Campaign No. :	Campaign Desc. :	Replace Fuel Delivery Module
2023090004	VS3KRAPUMP	
<p>This is to notify you of a Recall Campaign Launch to replace the fuel delivery module on approximately 1,121 MY 2021 Freightliner Sprinter vans. The recall campaign will be visible on the www.safercar.gov website and may generate questions from customers. All affected VINs will be flagged as "OPEN" in VMI and cannot be sold until the recall has been remedied.</p>		
Background		
Issue	<p>Mercedes-Benz AG, the manufacturer of Sprinter vans, has determined that on certain Sprinter (907 platform) vehicles the fuel pump impeller might not meet specifications in regards to material characteristics. As a consequence, the impeller might deform and come into contact with the fuel pump housing, leading to a mechanical resistance. In some instances, this could lead to a shutdown of the fuel pump. As a result, the vehicle could lose propulsion, which could increase the risk of a crash or injury.</p>

SUBJECT: **Model 907 Sprinter, Model Year 2021**
Replace Fuel Delivery Module

Order No. V-RC-2023090004

D47.20-A029-76

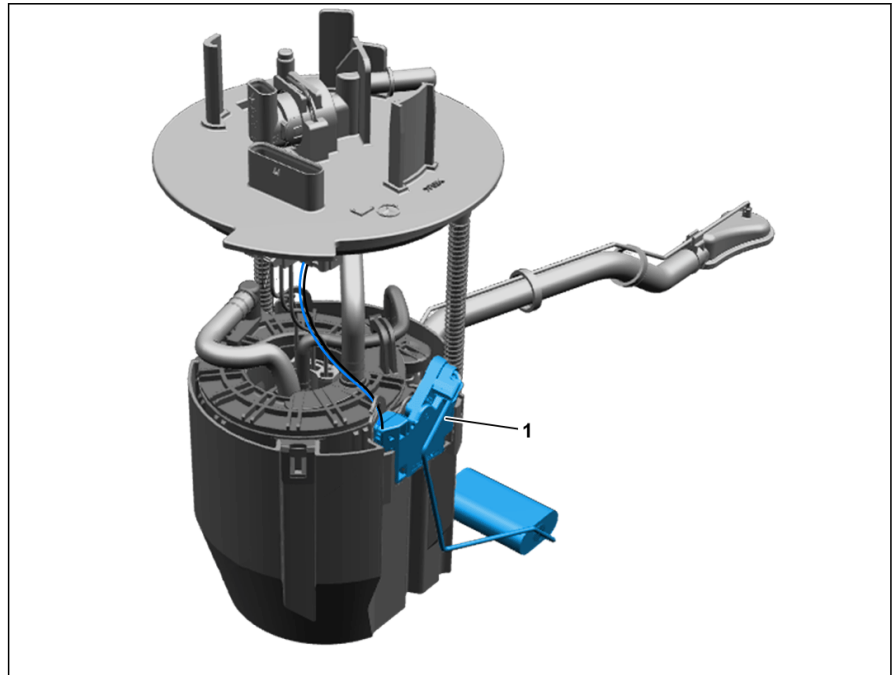
SM47.20-D-0027-02SG	Modify fill level sensor of fuel delivery module (code: VS3KRAPUMP, acc. no.: 47 902 07)		
---------------------	--	--	--

1 Fill level sensor

D47.20-A030-76

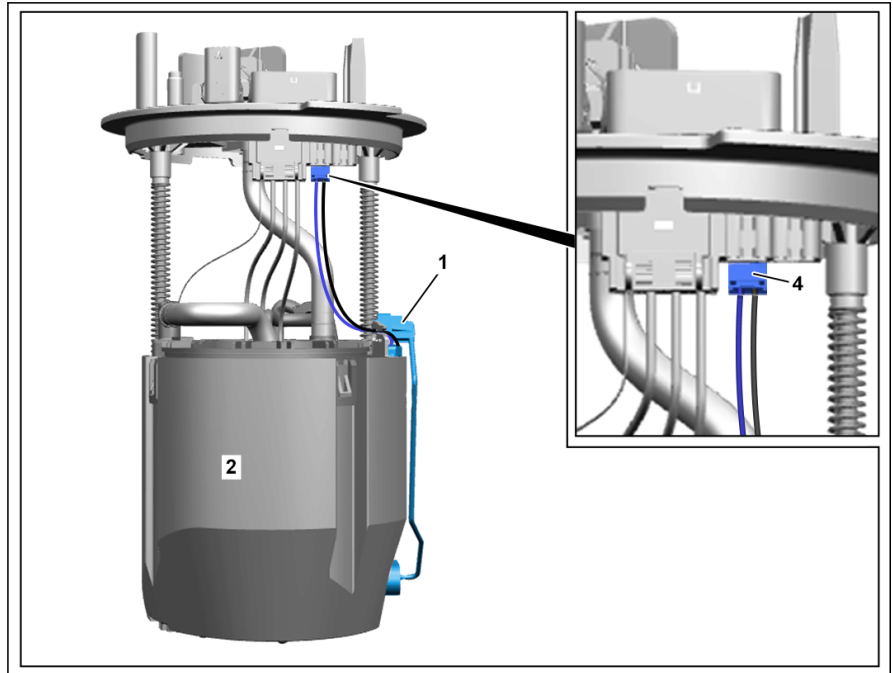
- 1 Release and disconnect electrical connector(4).

- 2 Unclip electric lines from line routing (3).

- 3 Push fill level sensor (1) forwards in area of line routing (3) and then unclip upwards.

i Installation:
Check that the fill level sensor (1) is correctly locked.

D47.20-A031-76

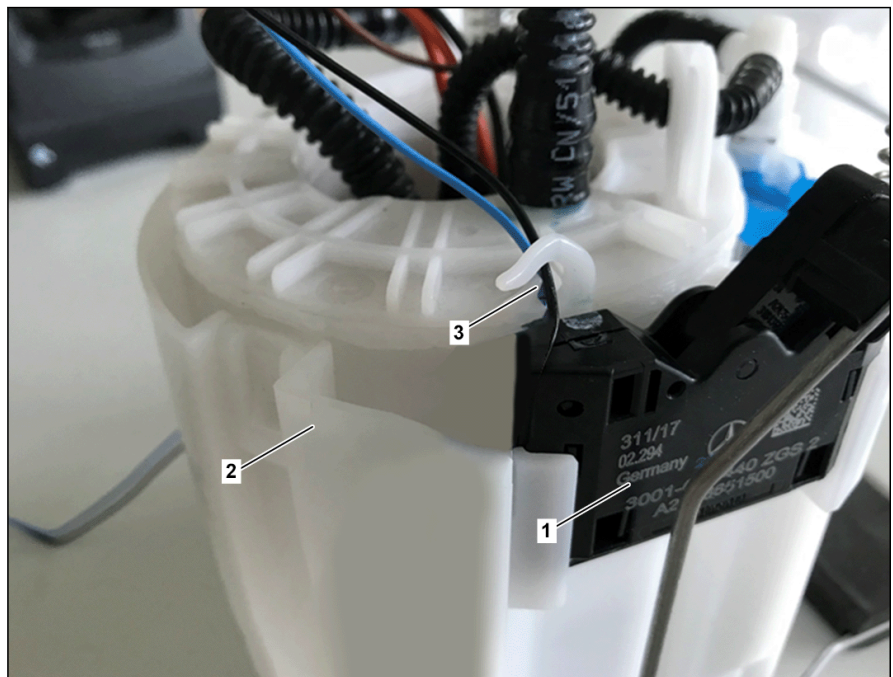
- 4 Install in the reverse order.
